# **Impact Area Groundwater Study Program**

### **Demo 1 Groundwater Operable Unit**

#### **Response to Comments Letter and Memorandum of Resolution**

**Re: Impact Area Groundwater Study Program (IAGWSP)  
USEPA Region I Administrative Orders SDWA 1-97-1019 and 1-2000-0014  
Response to Comments (RCL) on the Revised Draft Feasibility Study  
Demo 1 Groundwater Operable Unit**

FIGURE  
 F3-3

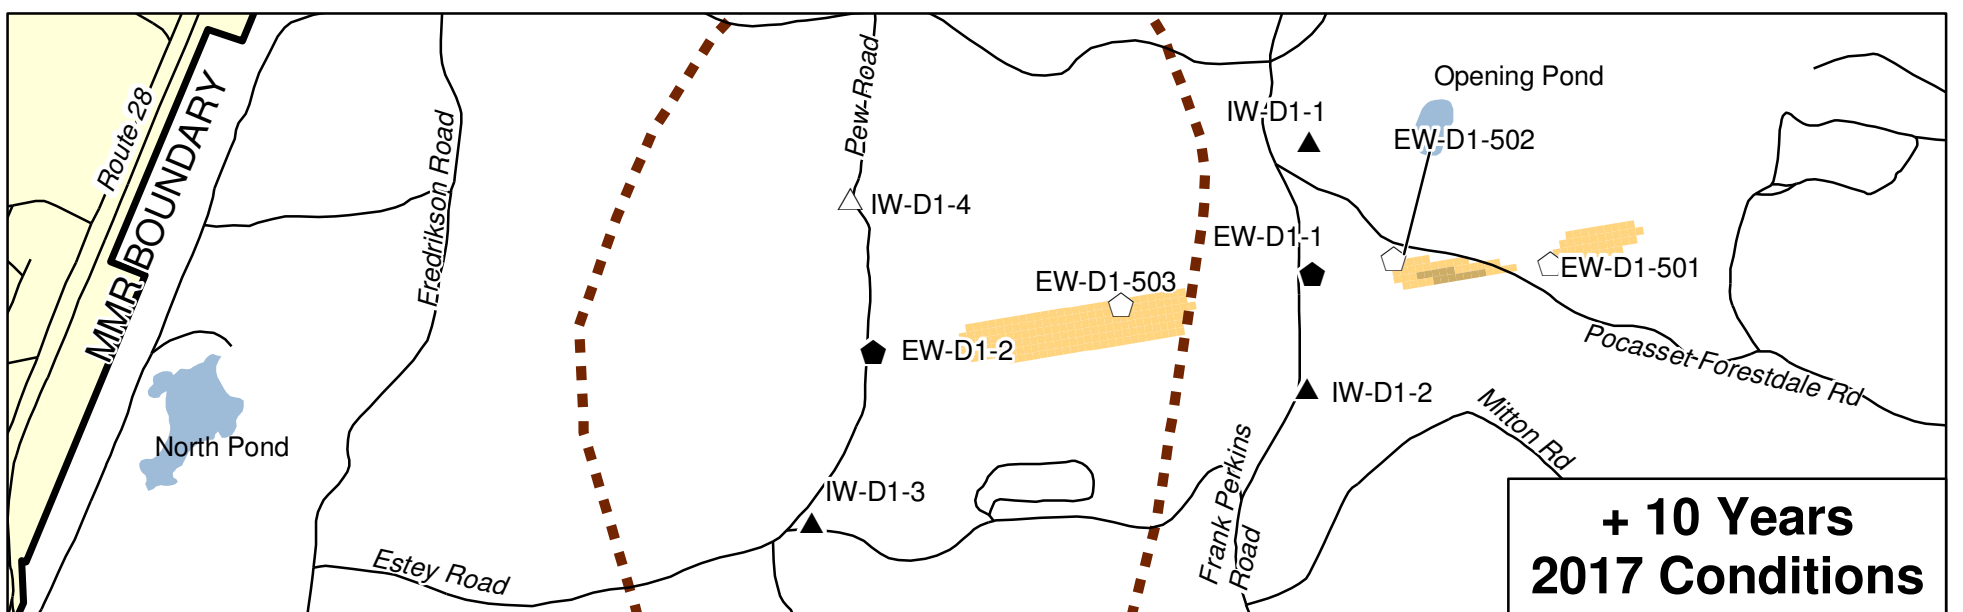
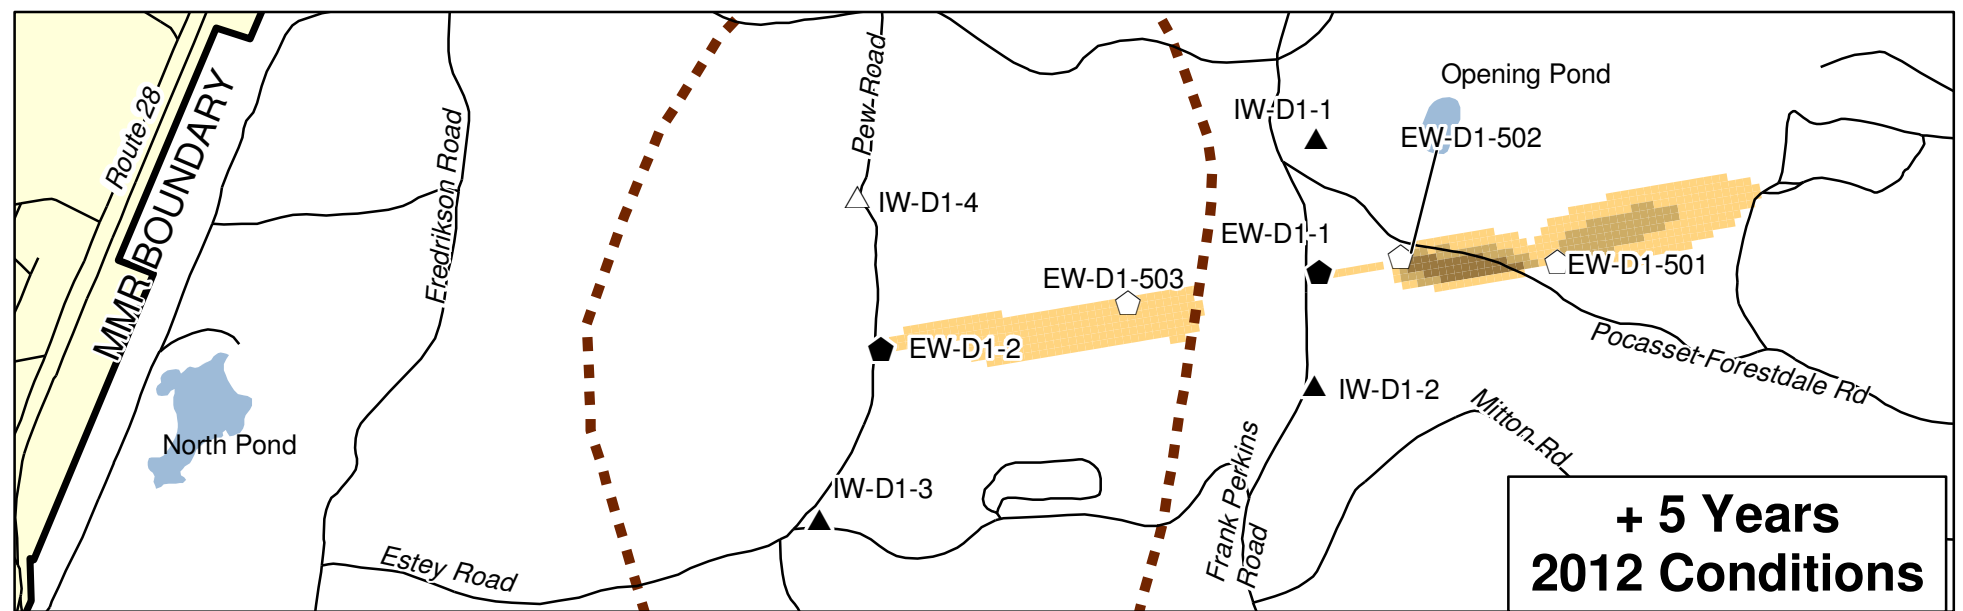
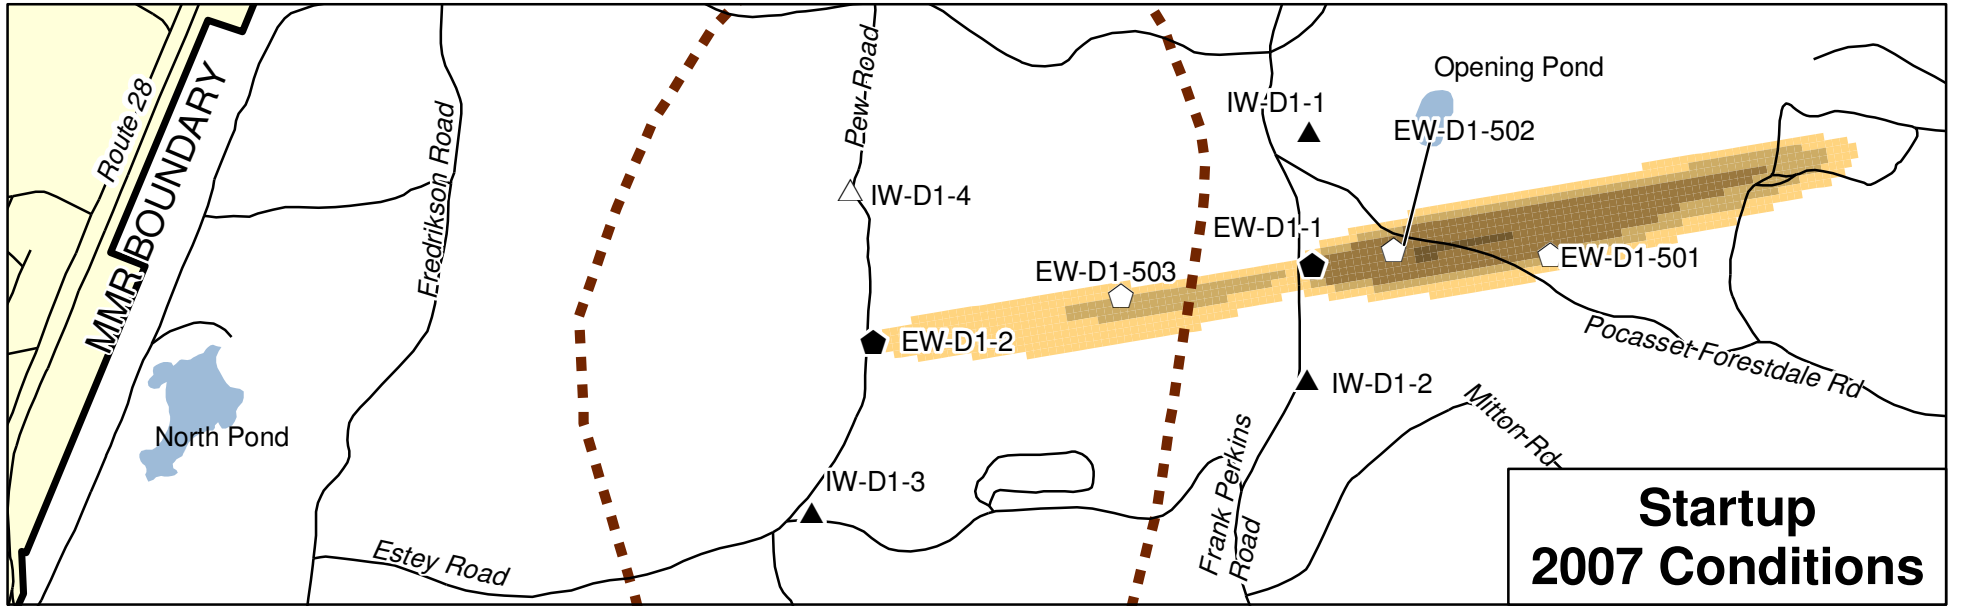
**EPA Comment 2 (04/19/05)** Figure F3-3: See above comment on Section 3.0. Please clarify why it appears that the Perchlorate plume in Figure F3-3 persists longer than the estimated years to achieve clean up in Table F3-1.

In addition, the Department notes that Figure F3-3 indicates that the maximum downgradient extent of the 1-4 ug/L model-computed perchlorate concentration by startup year 2007 terminates approximately 500 feet upgradient of Fredrikson Road. However, perchlorate concentrations greater than 1 ug/L are already being observed at MW-258 located just upgradient of Fredrikson Road. The December 2004 sampling results at MW-258 reported perchlorate concentrations of 0.47J ug/L, 1.62 ug/L and 1.01 ug/L for the M1, M2 and M3 well screens, respectively. Therefore, the model does not accurately reflect the distribution of perchlorate mass already known to be downgradient of Pew Road. Perchlorate concentrations have increased in all three well screens at MW-258 since it was installed in early 2003. This conclusively demonstrates the ability of perchlorate concentrations in the 1-4 ug/L concentration range to substantially migrate in the aquifer with minimal natural attenuation.

*Figures F3-2 and F3-3 (and also F3-4) portray maximum predicted concentrations within the 3-dimensional subsurface groundwater simulation projected onto the map plane. The maximum concentration is projected irrespective of depth. In the case of Demo 1 (and elsewhere on MMR) varying types of soil are present including both highly permeable sand and gravel aquifer materials and poorly permeable silts and clays that constitute an aquitard of limited local extent. The presence of this aquitard is influencing the vertical movement of the plume, essentially preventing downward migration that would result from the prevailing downward hydraulic gradients. On figures F3-2 and F-3-3, the estimated lateral extent of the interpreted aquitard is indicated with a dashed brown line.*
